**ACEC/NHDOT QUALITY
INITIATIVE ROUNDTABLE**

RECOMMENDATIONS REPORT

**HIGHWAY CONSTRUCTION PLAN
IMPROVEMENTS**

DATE: April 29, 2004

SAMPLE GRADING PLANS

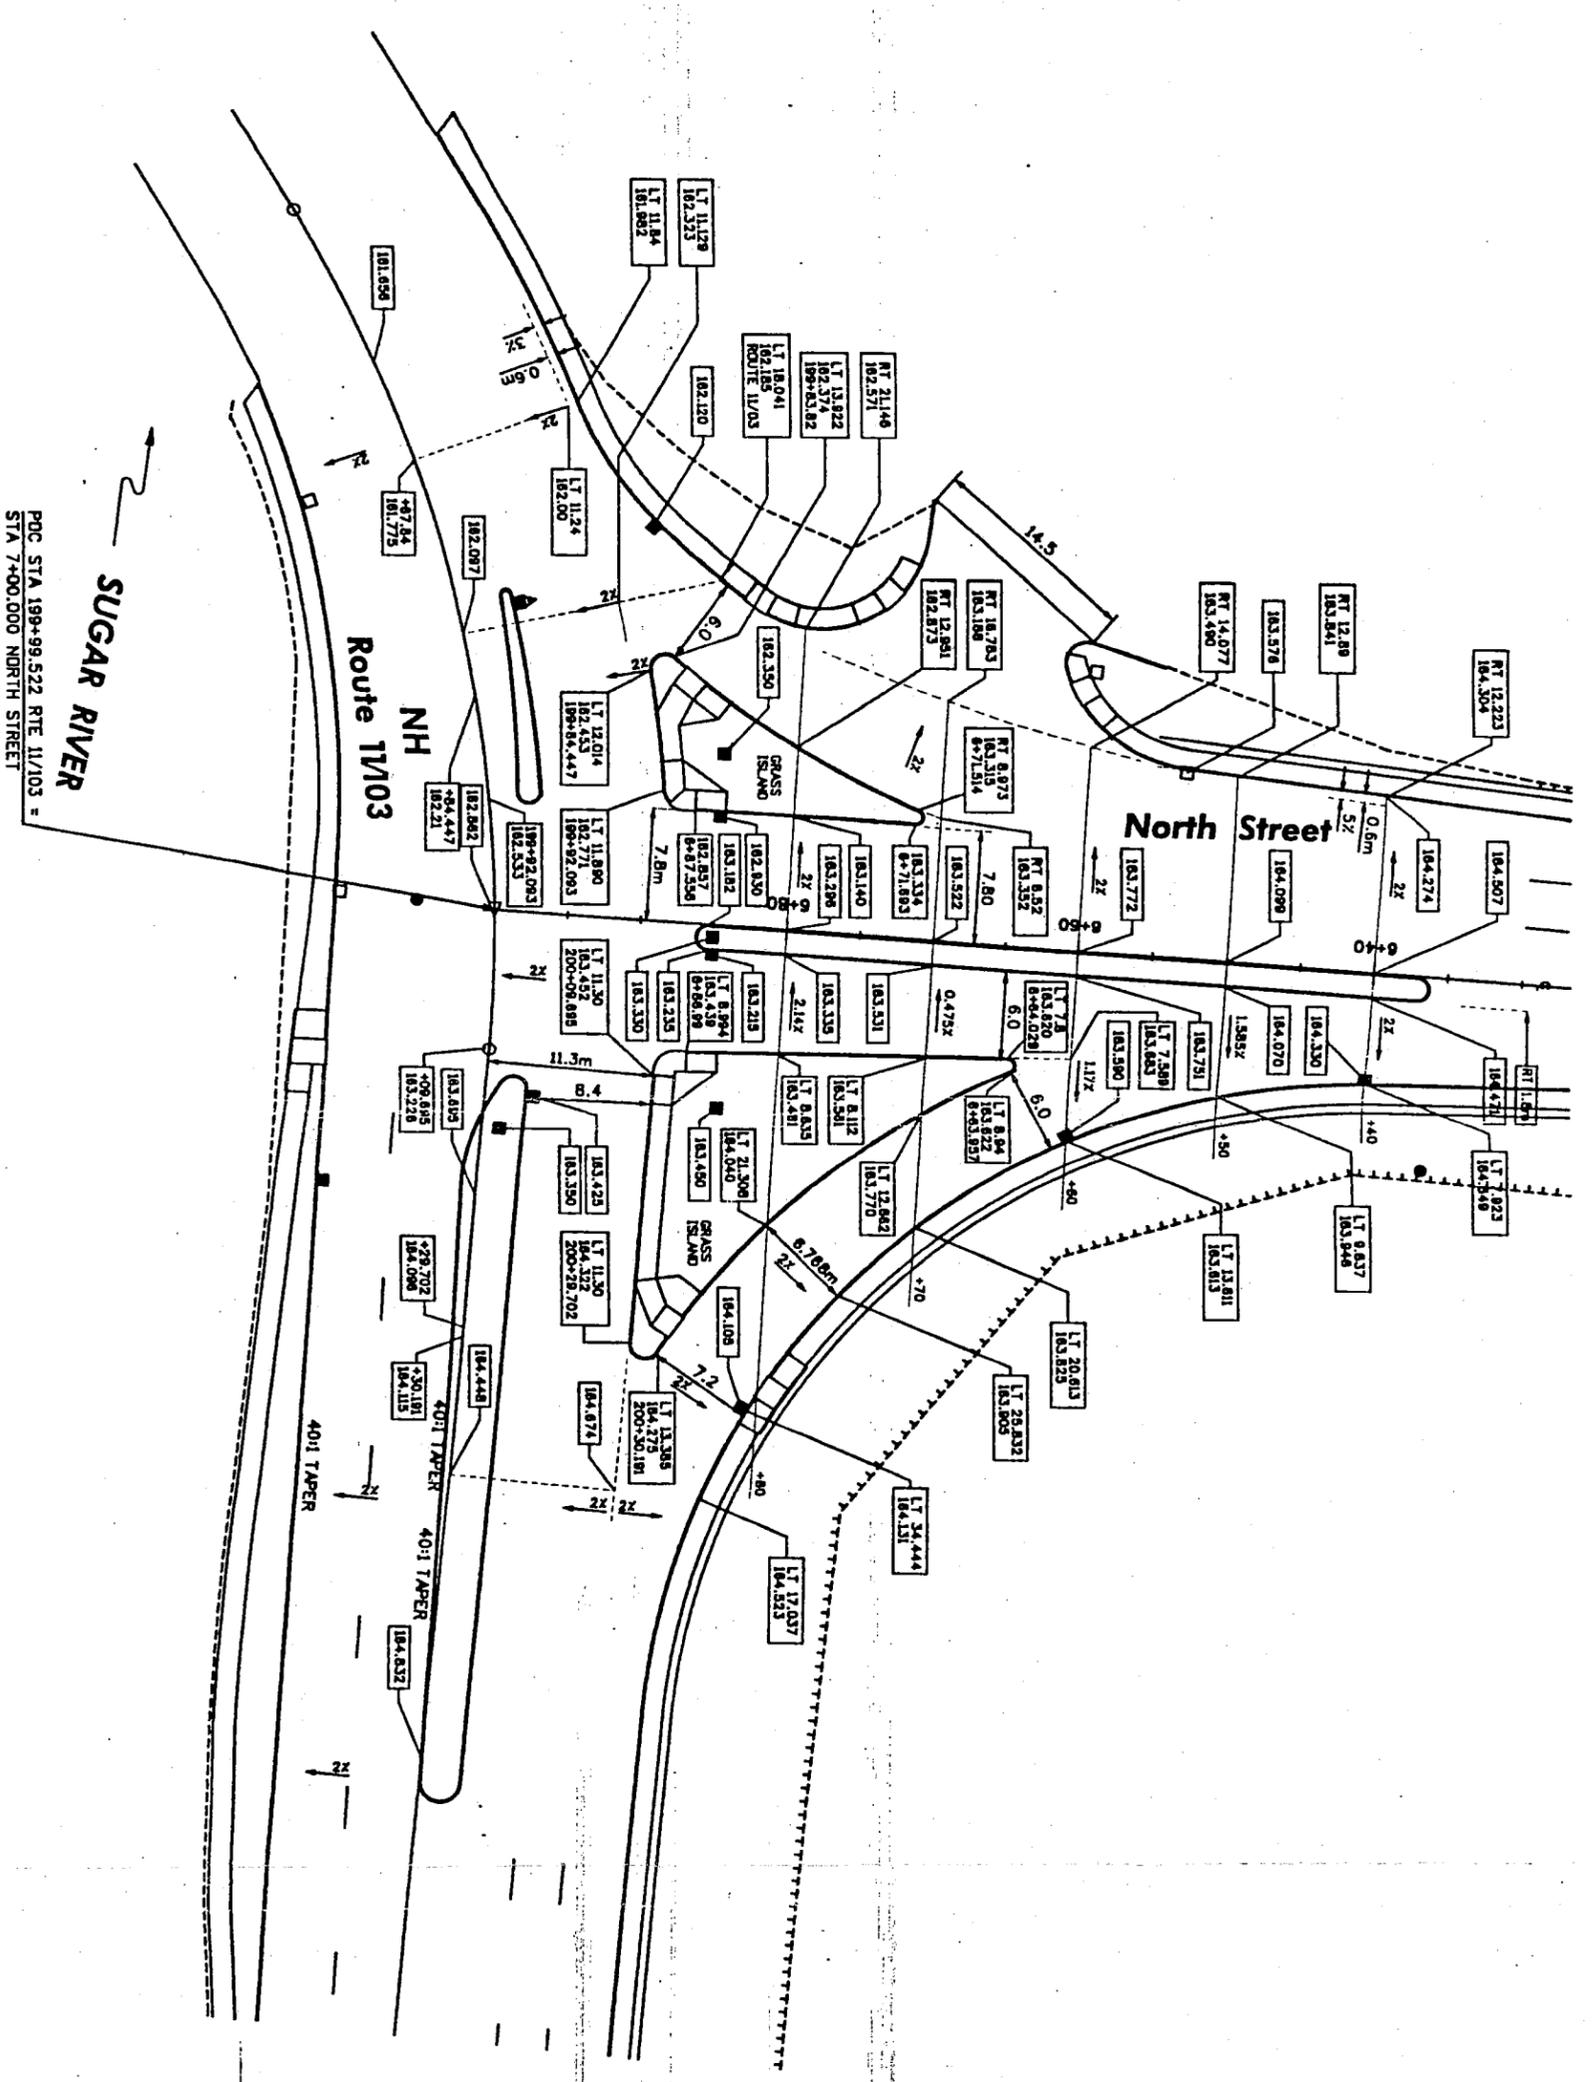
It's important that pavement be shaped correctly and that low points match the new drainage structures. At curbed intersections, especially those that have islands and "slip ramps", Grading Plans are relied upon to achieve the desired result. Generally speaking, the more complex the intersection is, the more important it is to include Grading Plans. It's also important to include spot elevations at all critical points of the intersection to complete the picture and not leave any "gaps" where field fitting would be required or inadvertent high or low spots or poor transitions may result. It was agreed to show the information by finished grade elevations with accompanying station and offset. Jim commented that this had a secondary benefit of

establishing the edges of ramps and islands such that the contractor can lay them out more easily when there is no separate alignment for them.

Ted will distribute a copy of an intersection Grading Plan developed for a recent consultant project in Claremont to the District Construction Engineers for comment. Suggested changes and additions will be returned to Craig to serve as an example of what to include for future projects that require Grading Plans. In the interim, it was agreed to review the projects currently under design and decide (with Construction) whether Grading Plans are required and, if practical, to include them in the Construction plans.

1. The Committee agrees with the Draft Memo, dated 10/24/02, regarding the intersection grading plans. See copy of memo and sample plans in Appendix D.
